TO: DEVELOPMENT REVIEW BOARD
FROM: CURRENT PLANNING SERVICES
SUBJECT: CASE 66-DR-2003

REQUEST: Approve site plan, landscape plan, & elevations for an office building at McDowell Mountain Ranch

PROJECT NAME: Offices at McDowell Mountain Ranch Parcel R

Site Plan

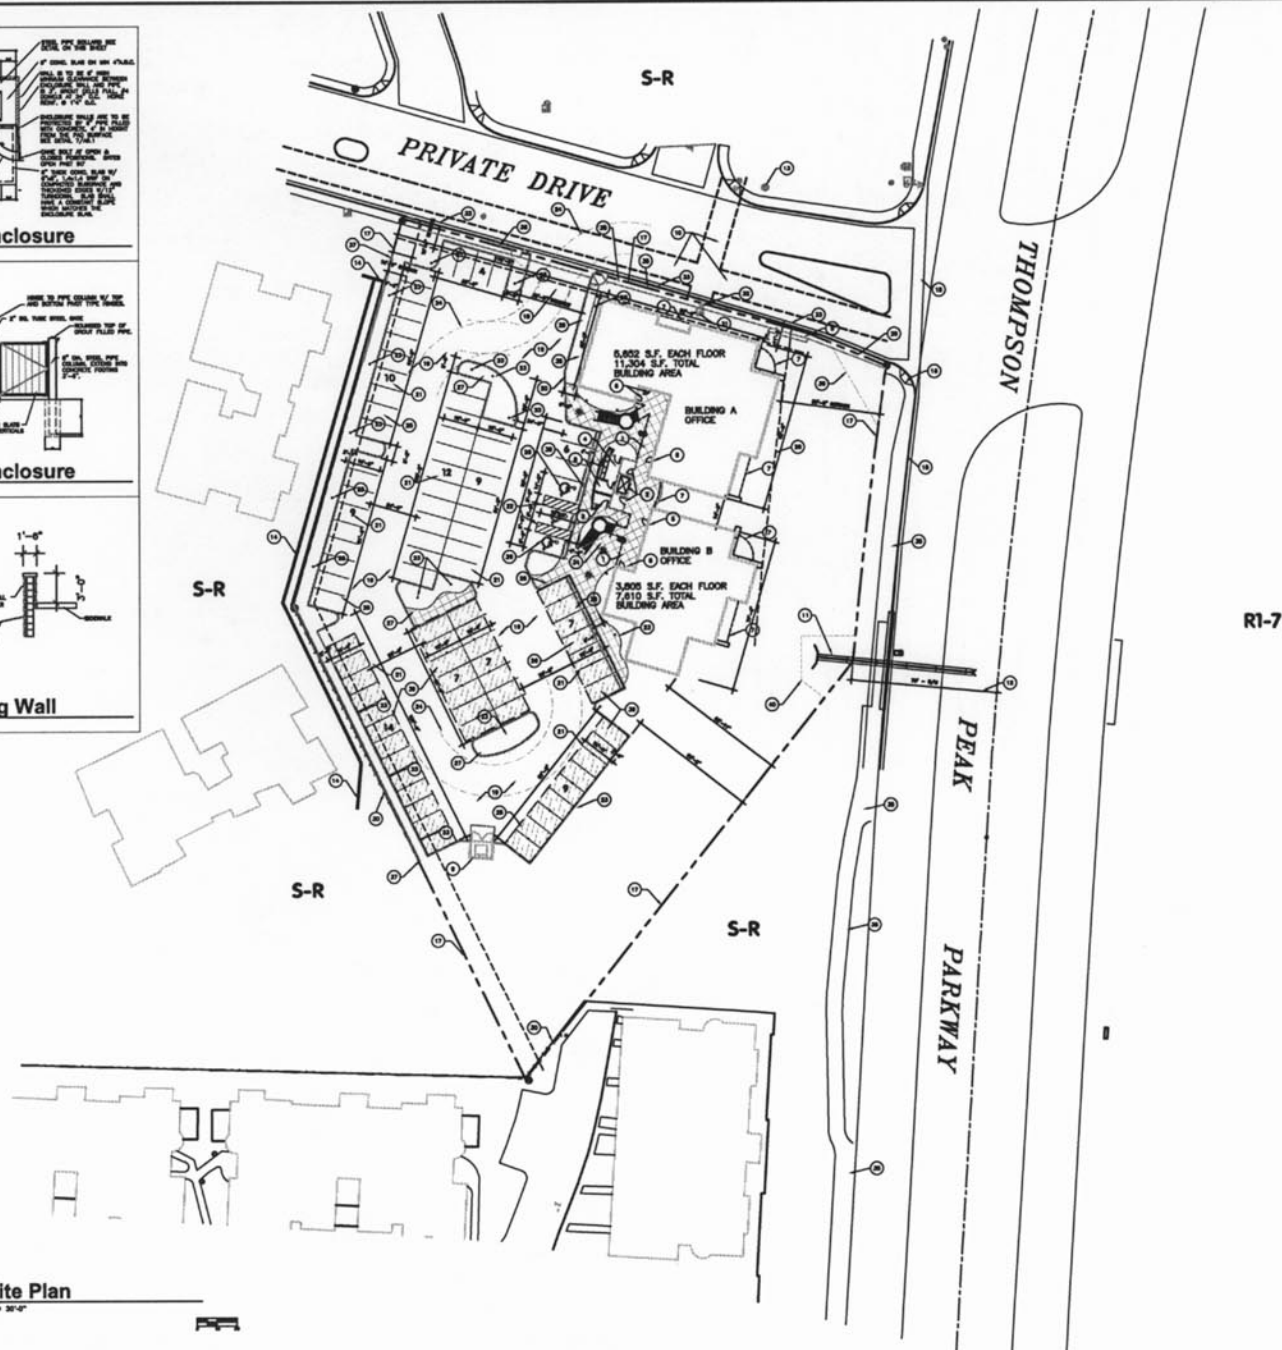
- 32. The site plan shall be revised to include sidewalk along the private drive frontage.

37. The trash enclosure location shall be revised so that it's approach direction is aligned with the travel direction of a drive aisles.
38. Refuse enclosures shall be constructed to City of Scottsdale's standards. Details for construction of trash enclosures can be found in the City of Scottsdale Supplements to MAG Standards, standard detail Enclosures must:
- a. Provide adequate truck turning/backing movements for a design vehicle of turning radius R (minimum) = 45 feet vehicle length of L = 40 feet.
 - b. Be positioned to facilitate collection without "backtracking."

EAST ELEVATION

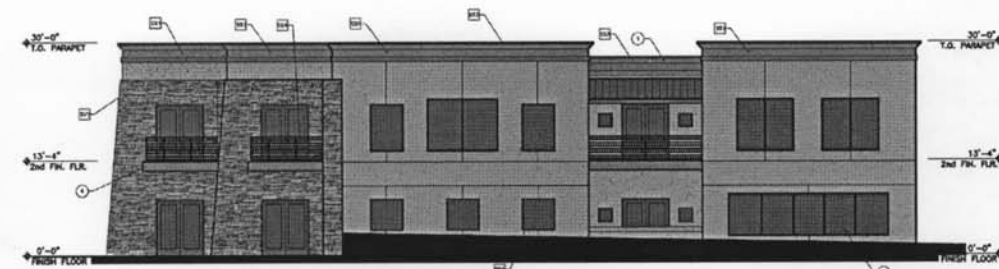
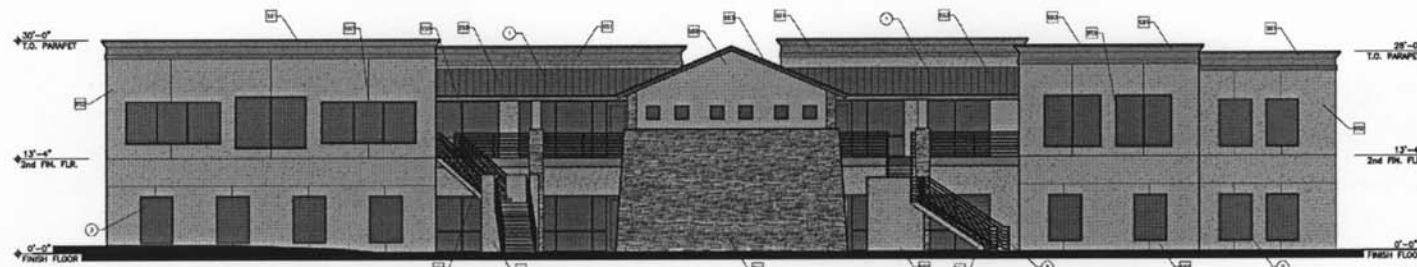
KEY ISSUES: The applicant has made revisions to the original elevations submitted to the City, but Staff feels a couple more minor additions could be incorporated into the design.

1. Substantial amounts of unprotected south and western glazing (Scottsdale Sensitive Design Principle #10)
2. Stucco forms lack a defined base to anchor forms to ground plane (Scottsdale Sensitive Design Principle # 9)

- a. Architectural elements, including dimensions, materials, form, color, and texture, shall be constructed to be consistent with the building elevations submitted by City Spaces with a date of 10/15/03 provide on the plans by City Staff.
